SERVICE BULLETIN

N° **189-177**

**ATA 55 - TAIL PLANE INSTALLATION UPGRADE**

Revision A of this SB has been issued to update the effectivity section of Part I, II and III.

**Figure 3**

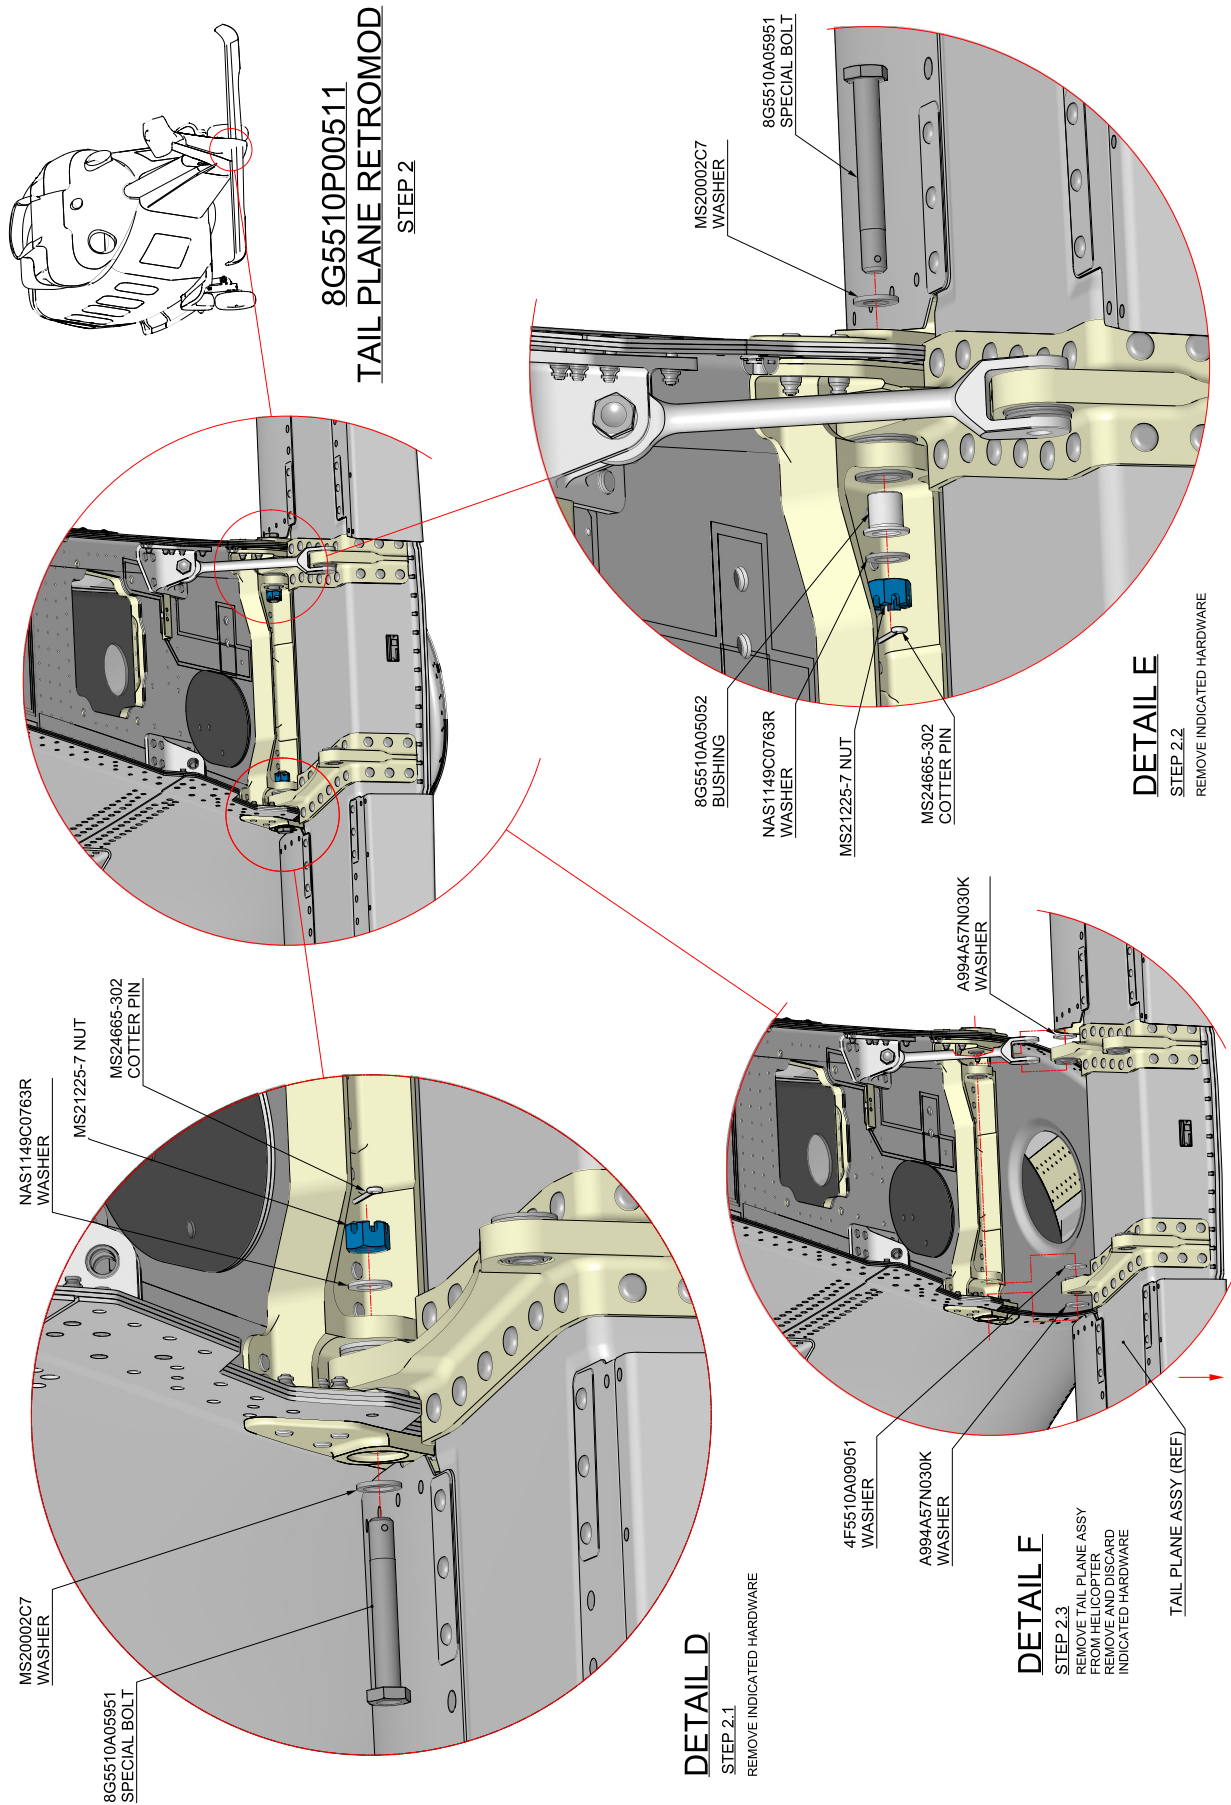
- 3.3 With reference to Figure 2 Detail C Step 1.3, remove the indicated hardware from RH rod assy P/N 8G5510A06032.
  - 3.4 With reference to Figure 3 Details D, E, F, Step 2 and in accordance with AMP DM 89-A-55-11-01-00A-520A-A, remove the indicated hardware and the tail plane from the helicopter. Discard the hardware.

**Figure 4**

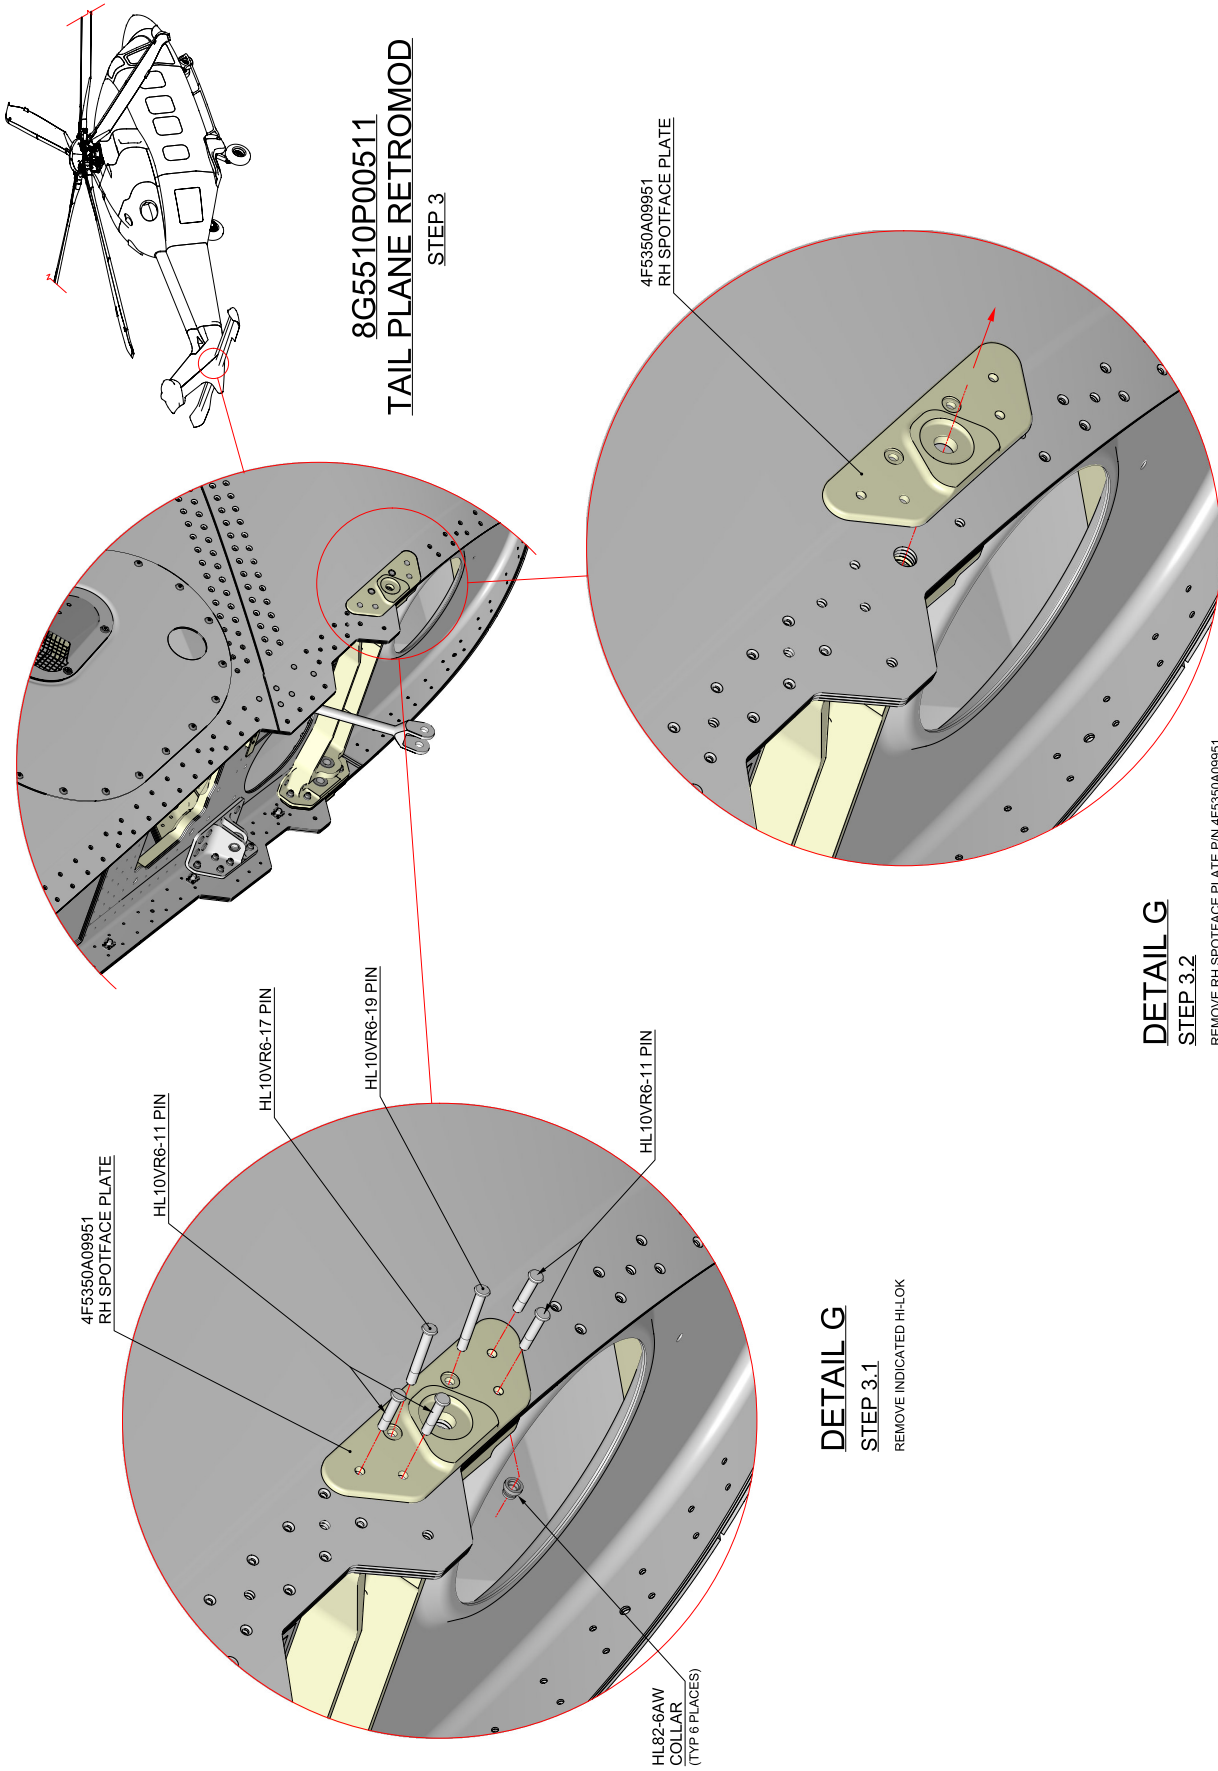
- 3.5 With reference to Figure 4 Detail G Step 3.1, remove the indicated Hi-Lok from the RH spotface plate P/N 4F5350A09951.
  - 3.6 With reference to Figure 4 Detail G Step 3.2, remove and discard the installed RH spotface plate P/N 4F5350A09951 from helicopter.

**Figure 8**

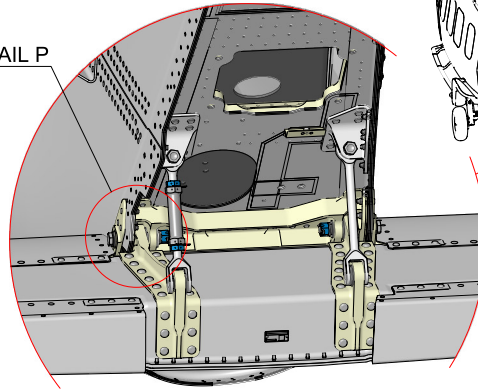
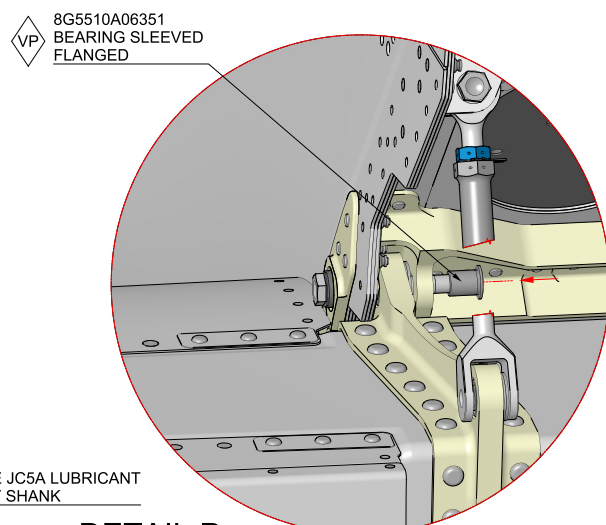
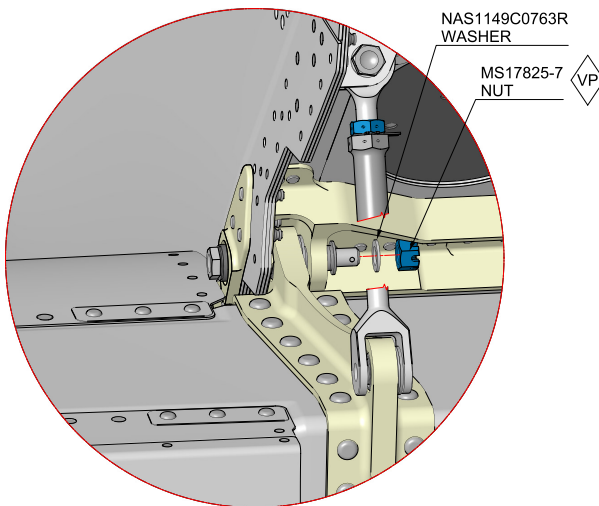
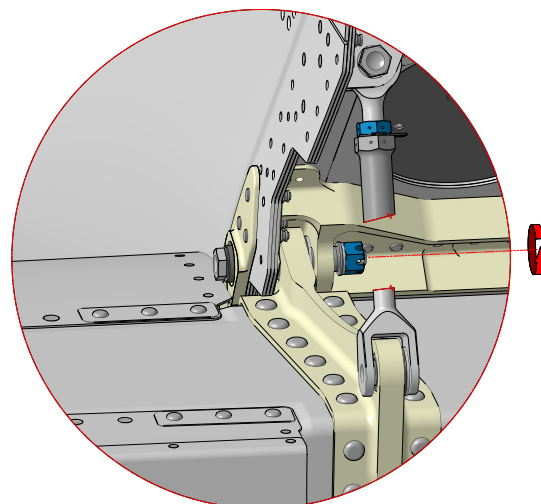
- 3.19 With reference to Figure 8 Detail P Step 7.1, install a bolt P/N 8G5510A05951, a convex washer P/N A904A07PV and a concave washer P/N A904A07PC.

- 3.20 With reference to Figure 8 Detail P Steps 7.2, 7.3 and 7.4, install the bearing sleeved flange P/N 8G5510A06351 and then a washer P/N NAS1149C0763R and a nut P/N MS17825-7; lightly tighten the nut.

**Figure 9**

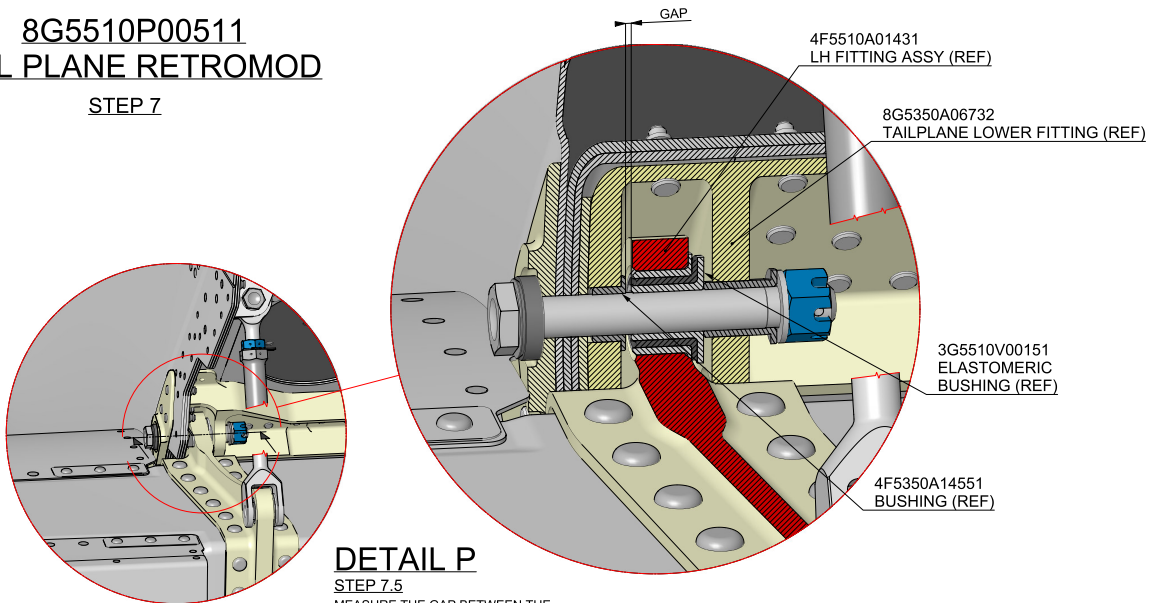
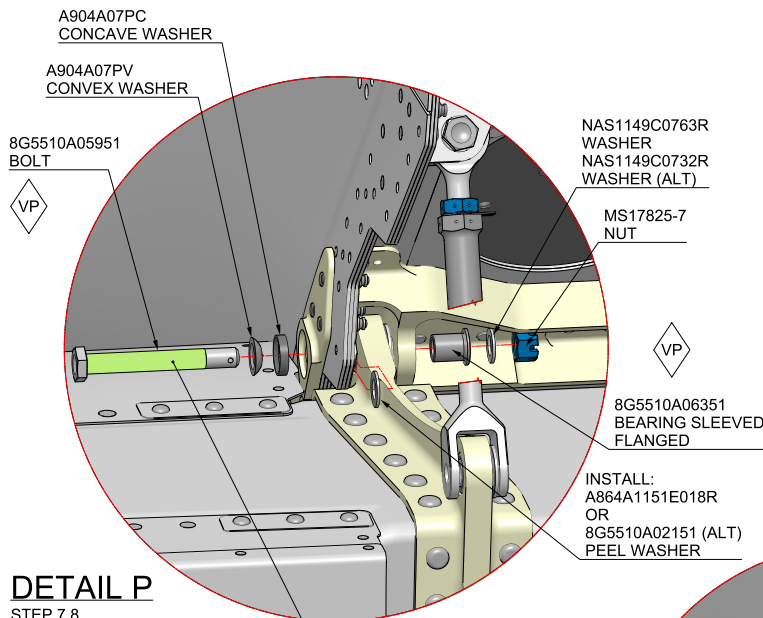
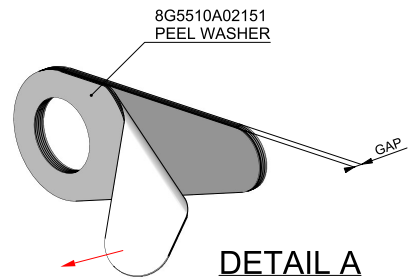
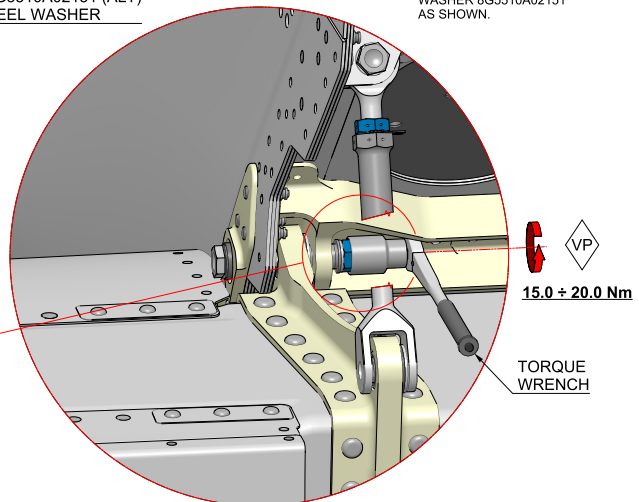
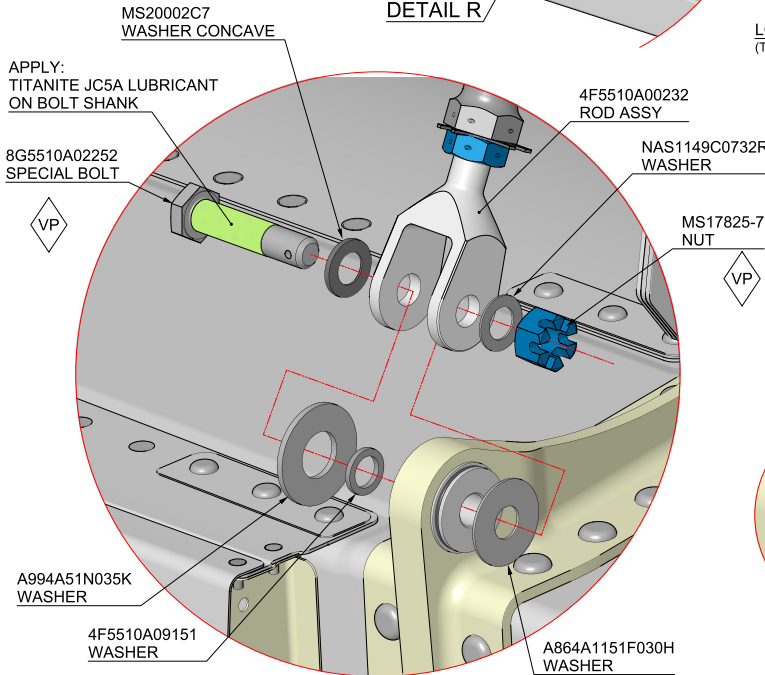
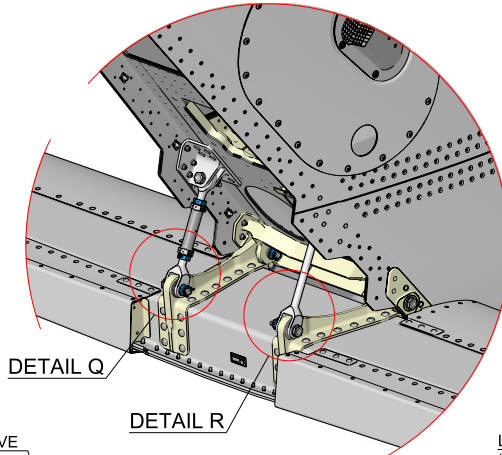
- 3.21 With reference to Figure 9 Detail P Step 7.5, measure the gap between the tailplane lower fitting bush and the tailplane elastomeric bushing.
- 3.22 With reference to Figure 9 Detail A Step 7.6, adjust the thickness of the peel washer P/N A864A1151E018R or P/N 8G5510A02151 to match the gap measured at previous step.

- 3.23 If the peel washer supplied is P/N 8G5510A02151, with reference to Figure 9 Detail A Step 7.7, trim the peel washer to obtain a circular shape with external radius of 10.0. After cutting, remove any sharp edges.

- 3.24 With reference to Figure 9 Detail P Step 7.8, remove the hardware installed at steps 3.19 and 3.20 and install the peel washer P/N 8G5510A02151 or P/N A864A1151E018R.

- 3.26 With reference to Figure 9 Detail P Step 7.9, torque the nut to 15.0±20.0 Nm; lock the nut by means of cotter pin P/N MS24665-302.
- 3.27 With reference to Figure 10 Detail Q Step 8.1, install a washer P/N A994A51N035K, a washer P/N 4F5510A09151 and a washer P/N A864A1151F030H in the indicated position of the tailplane LH fitting.

TORQUE THE NUT TO 20.0 Nm  
UNDO NUT AND BOLT TO RELEASE THE RUN DOWN TORQUE  
TORQUE THE NUT TO FINAL TORQUE:  
15.0 + 20.0 Nm  
LOCK THE NUT WITH INDICATED COTTER PIN.

**Figure 10**

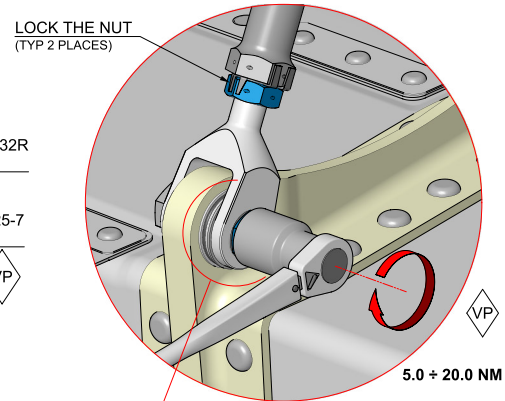
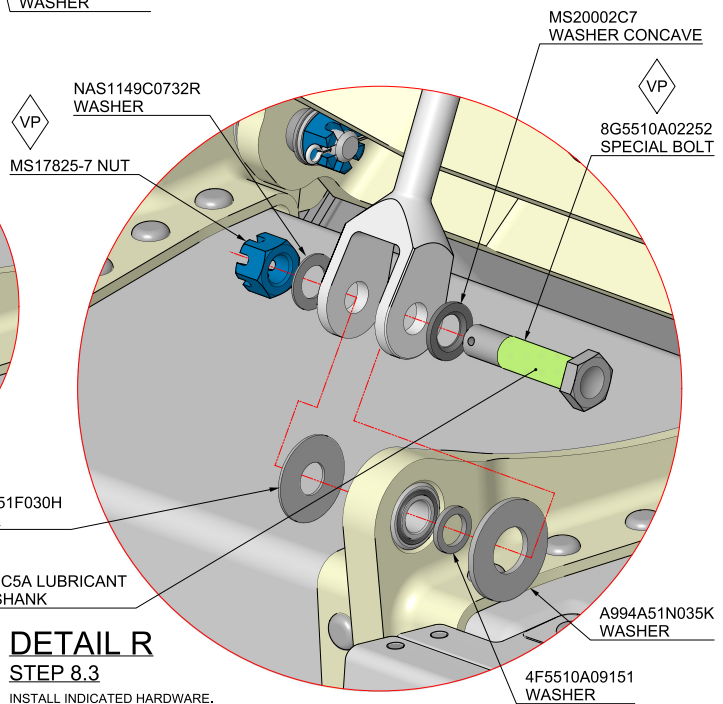
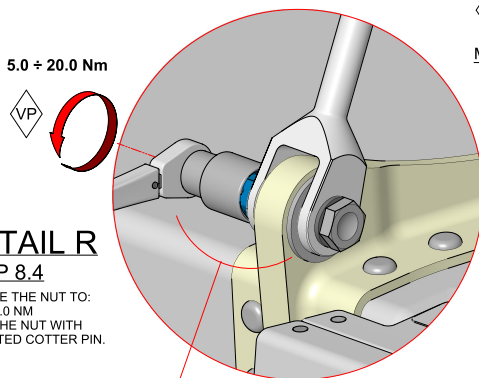
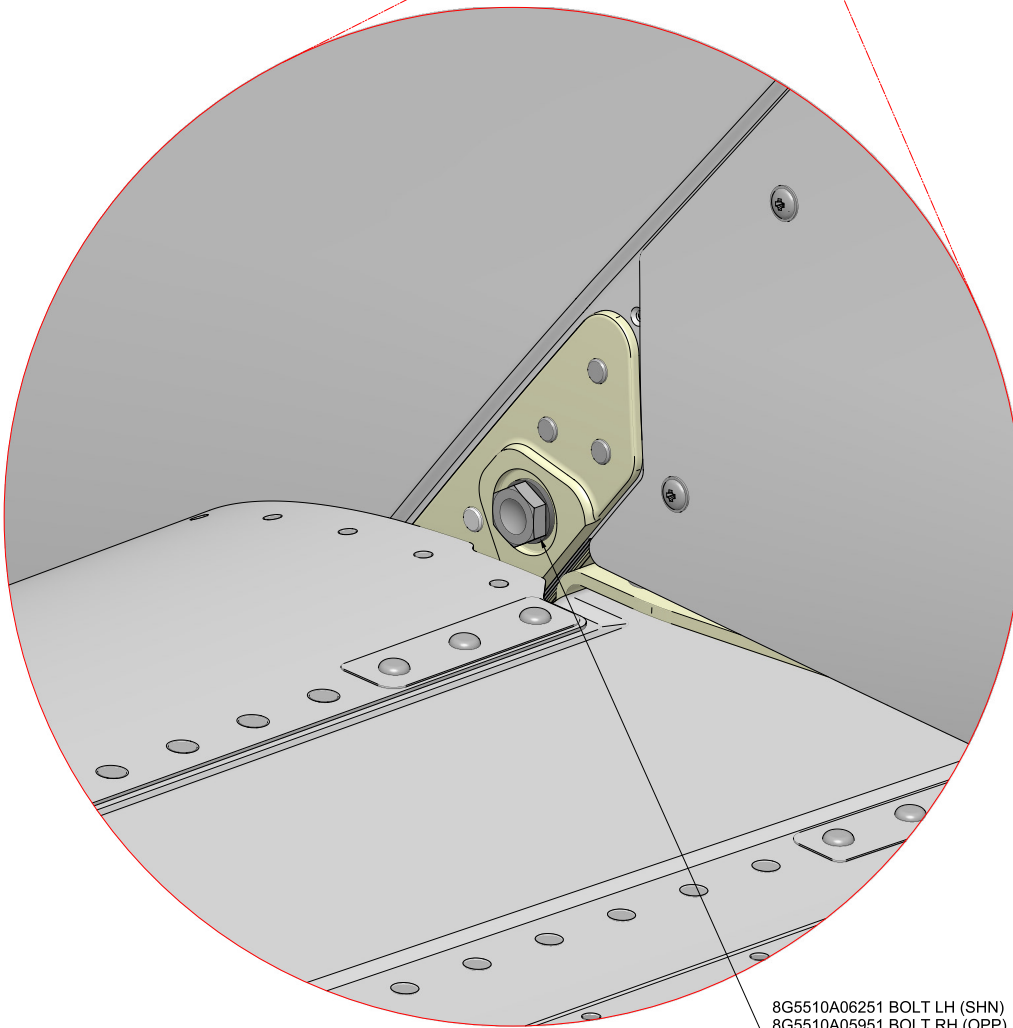
- 3.28 With reference to Figure 10 Detail Q Step 8.1, secure the rod assy P/N 4F5510A00232 to the tailplane LH fitting by means of bolt P/N 8G5510A02252, a washer P/N MS20002C7, a washer P/N NAS1149C0732R and a nut P/N MS17825-7.
- 3.29 With reference to Figure 10 Detail Q Step 8.2, torque the nut to 5.0±20.0 Nm; lock the nut by means of cotter pin P/N MS24665-302.
- 3.30 With reference to Figure 10 Detail R Step 8.3, install a washer P/N A994A51N035K, a washer P/N 4F5510A09151 and a washer P/N A864A1151F030H in the indicated position of the tailplane RH fitting.

- 3.32 With reference to Figure 10 Detail R Step 8.4, torque the nut to 5.0±20.0 Nm; lock the nut by means of cotter pin P/N MS24665-302.
- 3.33 Check the tailplane installation: If excessive movement of the tailplane assy is experienced, it is allowed to adjust the LH rod assy P/N 4F5510A00232 by unlocking the pitch link sleeve and rotating it to increase the overall length of the rod. Lock the pitch link sleeve rotation by means of installed nuts and lock washers. Safety the nuts on the rod by means of lock wire P/N MS20995C42.

TORQUE THE NUT TO:  
5.0 ± 20.0 NM  
LOCK THE NUT WITH  
INDICATED COTTER-PIN.

**Figure 11**

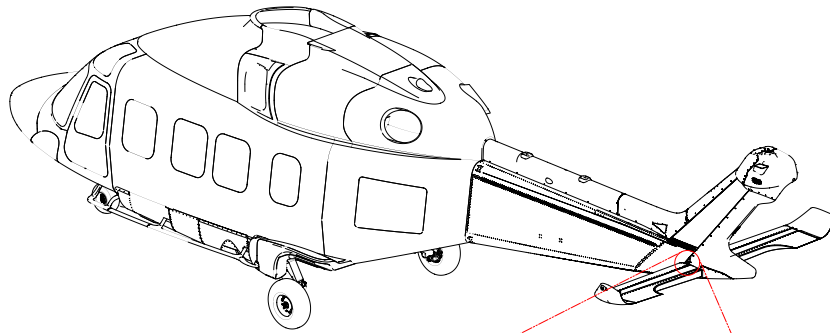
- 3.7 With reference to Figure 5 Detail H Step 4.1 and Figure 11, carefully remove and discard the indicated bush from the lower fitting assy P/N 8G5350A06732 by means of bush extractor tool P/N 8G5350G00731.
